Subject: Duke Energy Carolinas, LLC (Duke Energy)  
William States Lee III Nuclear Station - Docket Nos. 52-018 and 52-019  
AP1000 Combined License Application for the  
William States Lee III Nuclear Station Units 1 and 2  
Responses to Request for Additional Information  
Ltr# WLG2011.07-04

- 1) RAI 206 Supplement, Alternatives
- 2) RAI 216 Supplement, Alternatives
- 3) RAI 128 Supplement, Alternatives
- 4) RAIs 48, 114 and 123 Supplement, Alternatives

**Lee Nuclear Station Response to Request for Additional Information (RAI)**

to this letter). Histograms showing drawdowns of Make-Up Pond B and Make-Up Pond C for this scenario, originally provided in Duke Energy's response to ER RAI 123 (Reference 3) have been revised and are provided as Attachments 123S-02 through 123S-05.

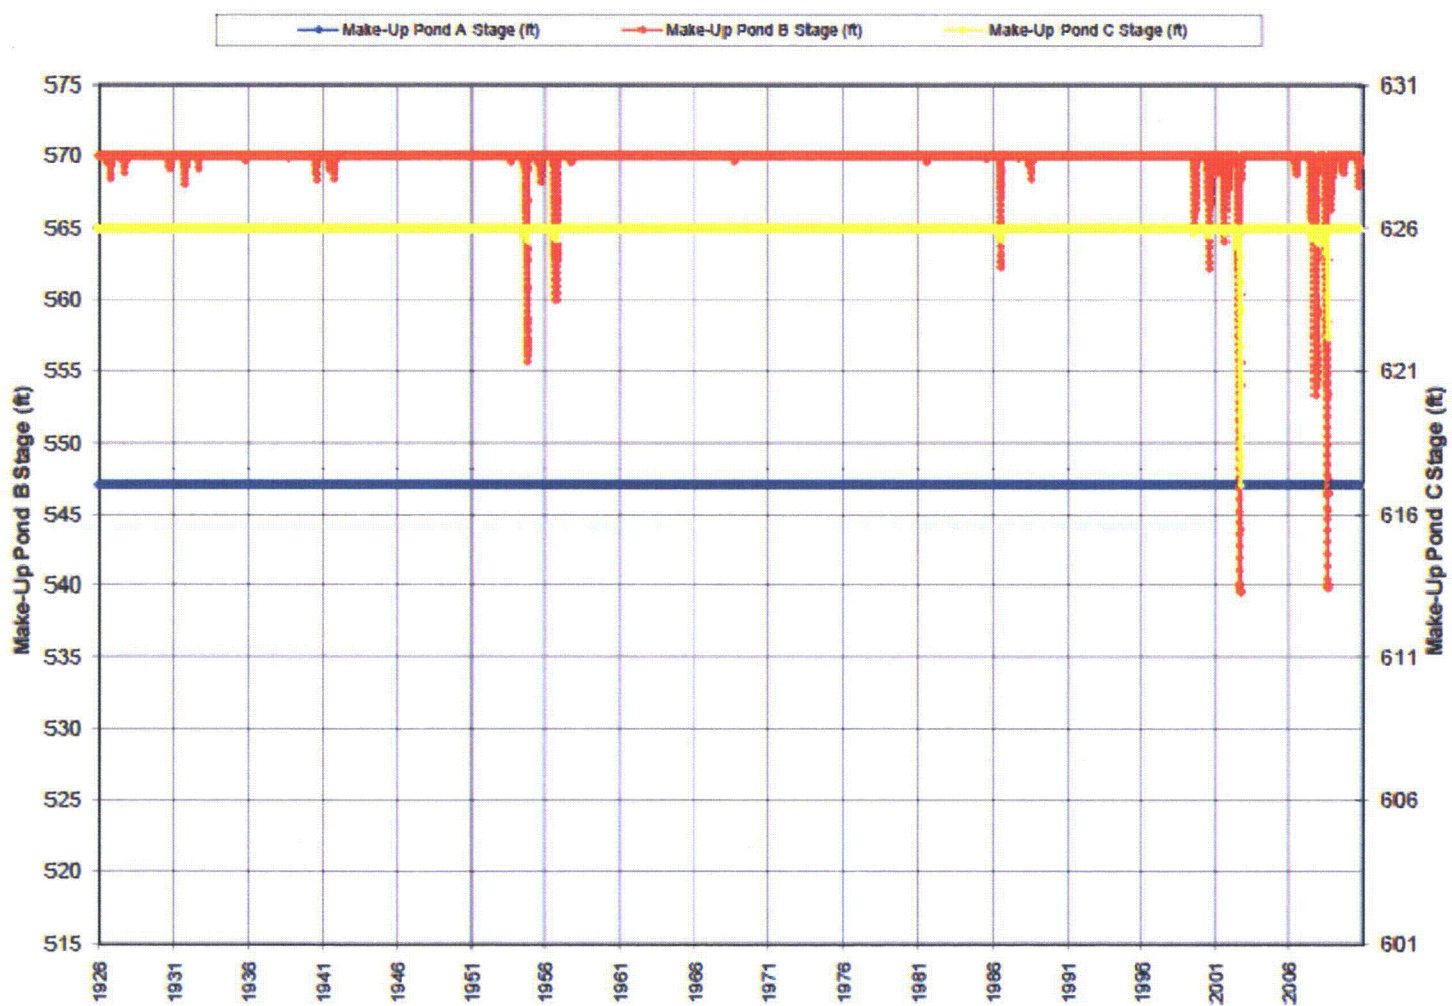
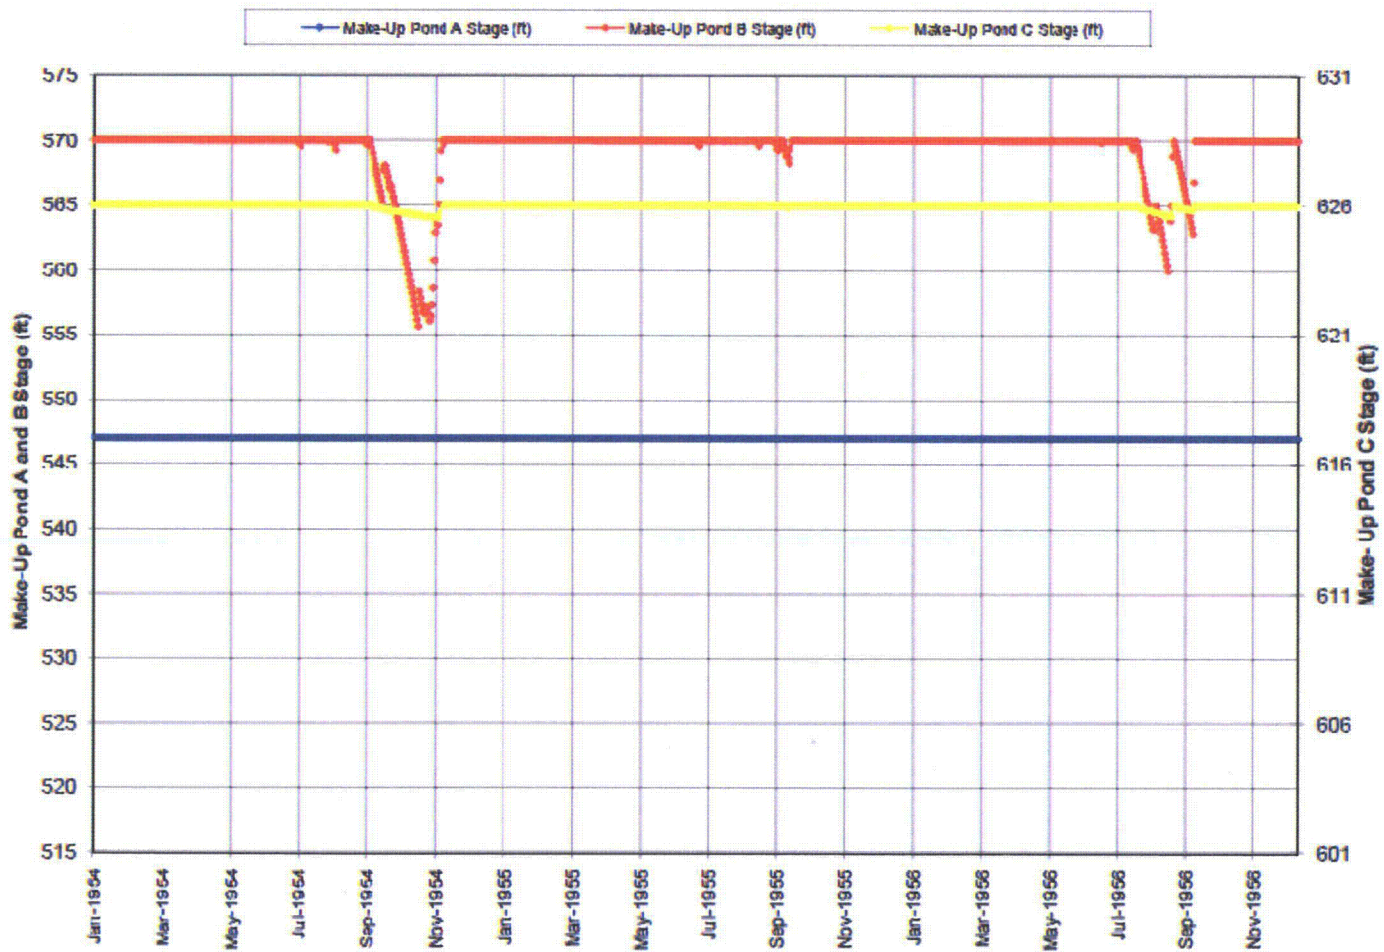
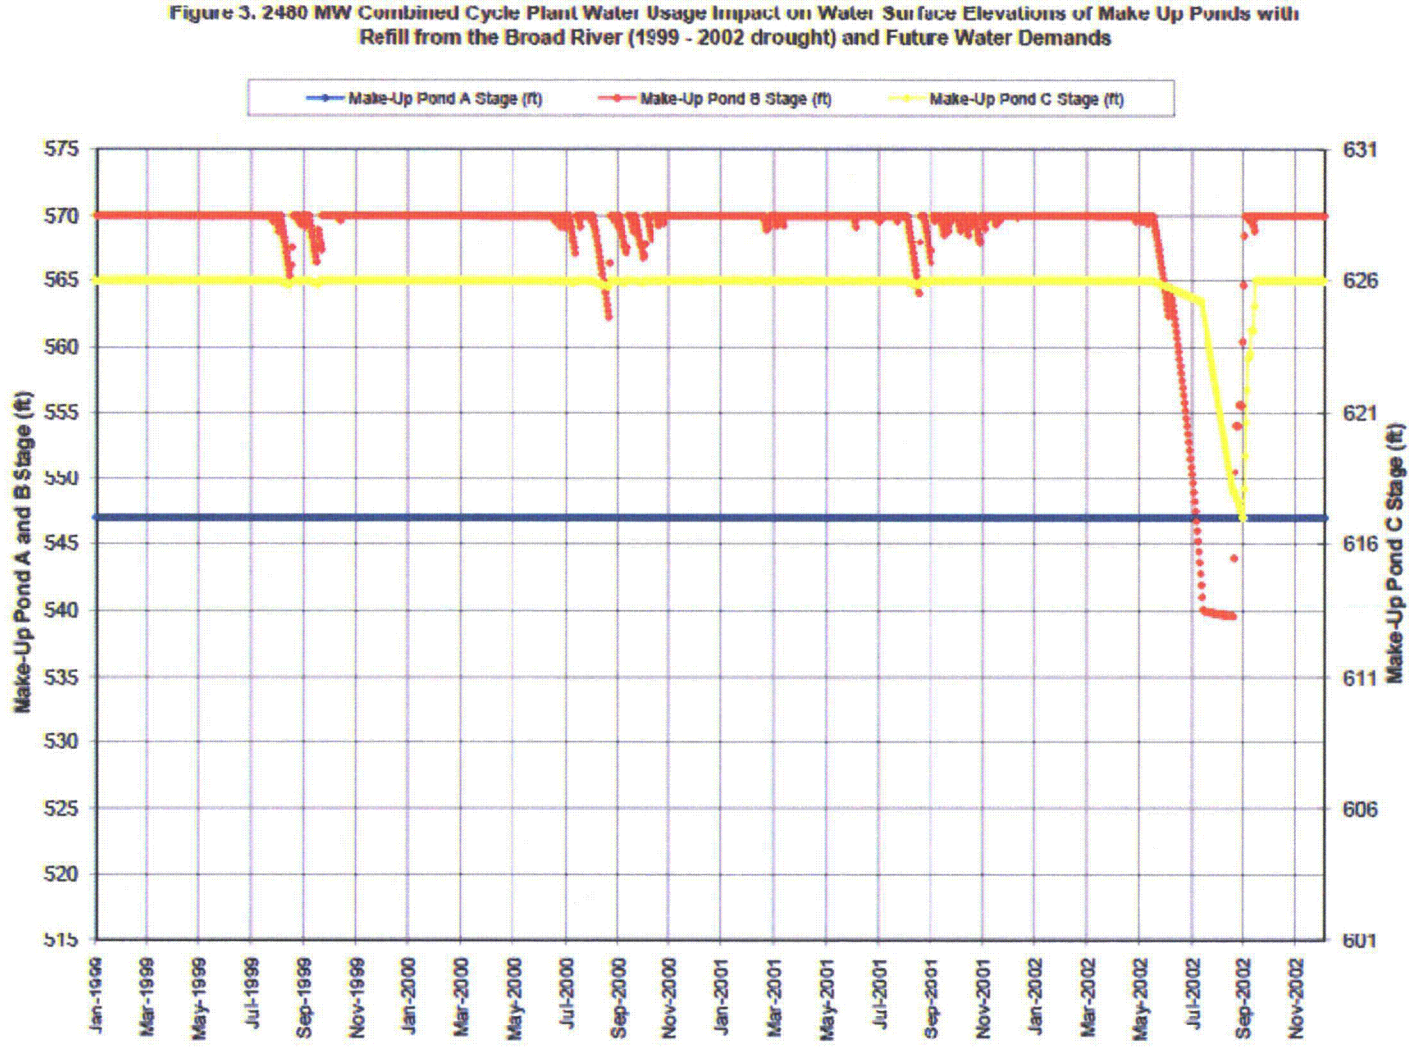
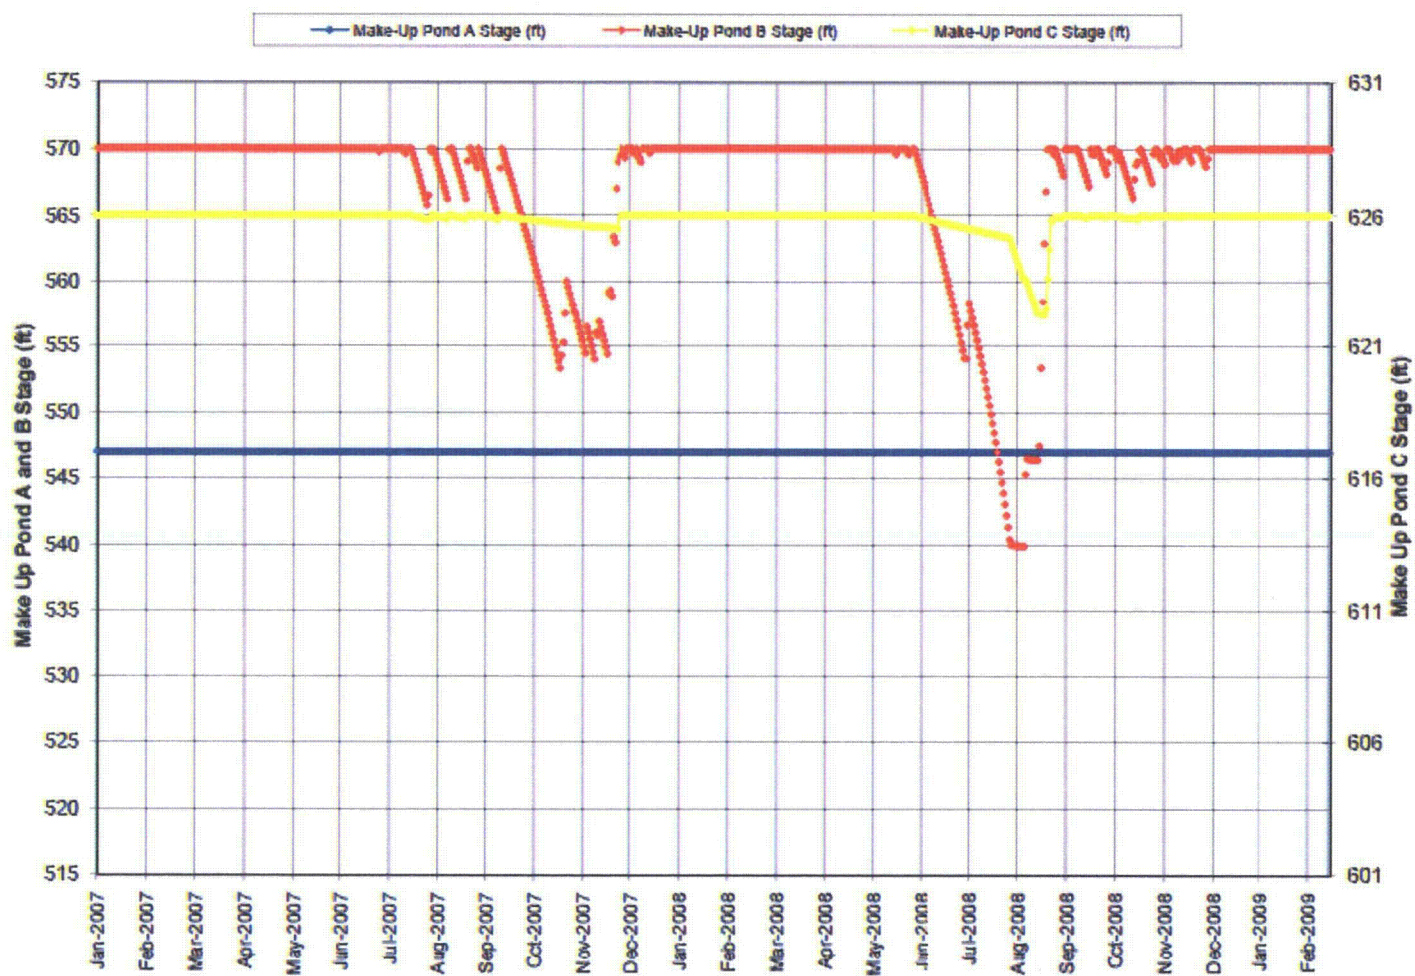
- Present the water balance model/results for the most recent 10 year period of flow data for the Broad River (2001 through 2010)
- Present the water balance model/results based on the hypothetical condition that the seasonal flow release limits in the Federal Energy Regulatory Commission (FERC) license for the Ninety-Nine Islands Dam would apply as constraints on Lee Nuclear Station withdrawals (bounding evaluation)
- Provide land use and ecology impacts for supplemental water options of (a) building a smaller Make-Up Pond C and (b) expanding Make-Up Pond B to support operation of a four unit natural gas combined cycle station at the Lee Nuclear Station site.

**Figure 6. Make-Up Pond B Excavation**

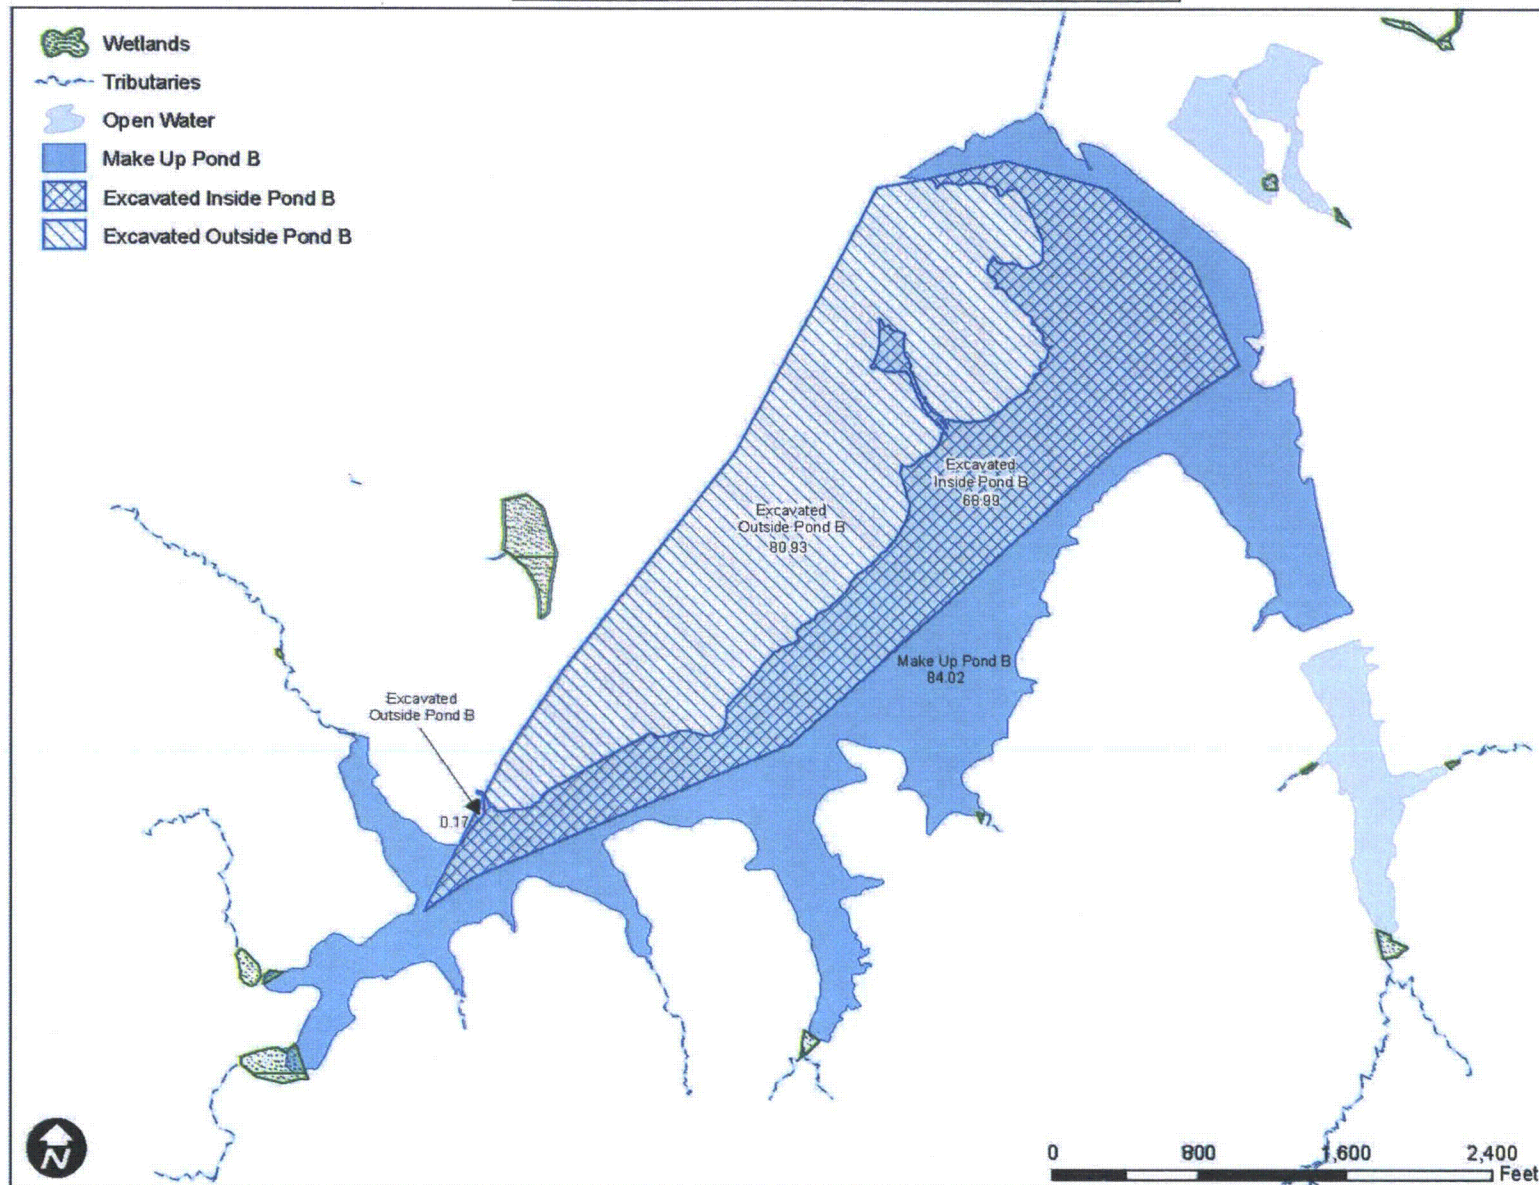
At the June 2 and 3, 2011 NRC audit, the NRC Staff requested that Duke Energy evaluate enlarging Make-Up Pond B to provide supplemental cooling water for a Natural Gas Combined Cycle generation alternative. Duke Energy's response to ER RAI 128 (Reference 4) concluded that expanding Make-Up Pond B to provide supplemental cooling water for a hybrid (wet-dry) cooling alternative was not an environmentally superior alternative. Water balance model results based on Natural Gas Combined Cycle and 5% Mean Annual Flow of 125 cfs relative to expansion of Make-Up Pond B are summarized below. Note that these results reflect only the additional volume of supplemental water required to support station operations through significant droughts beyond the usable storage volume of 3,156 ac-ft of storage used from existing Make-Up Pond B.

Expanding existing Make-Up Pond B to provide supplemental make-up water during times of drought for the Lee Nuclear Station was evaluated in the ER Supplement and Duke Energy's response to ER RAI 128 (Reference 4). Raising the height of the Make-Up Pond B dam and excavating the entire pond were evaluated to provide the supplemental storage volume. These evaluations identified flood protection concerns with raising the Make-Up Pond B dam to increase storage. Upon further evaluation, Duke Energy determined that it would not be possible to obtain the volume of storage required for the natural gas combined cycle plant while maintaining 3:1 slopes within the existing pond footprint. Therefore, Duke Energy evaluated an option to excavate the land adjacent to the northern and western shore of the pond to obtain the required storage volume. With this approach, the northern portion of Make-Up Pond B and the adjacent uplands would be excavated to 510 ft msl while maintaining 3:1 slopes. To accomplish this expansion, Make-Up Pond B would be completely drained and excavators used to obtain the required depth. Approximately 69 ac of Make-Up Pond B and 81 ac of additional area would be excavated as shown in Attachment 123S-08. Approximately 11 million cubic yards of unconsolidated material would be excavated.

If Make-Up Pond B were excavated to provide supplemental make-up water, the pond would be completely dewatered. Existing fish and other aquatic communities would be eliminated during the excavation. Removal of the surface water would substantially reduce hydrology of wetlands adjacent to Make-Up Pond B and would lead to temporary impacts. Excavation into the uplands would impact forested and non-forested communities. Impacts to vegetation due to the Make-Up Pond B excavation are provided in Attachment 123S-06.
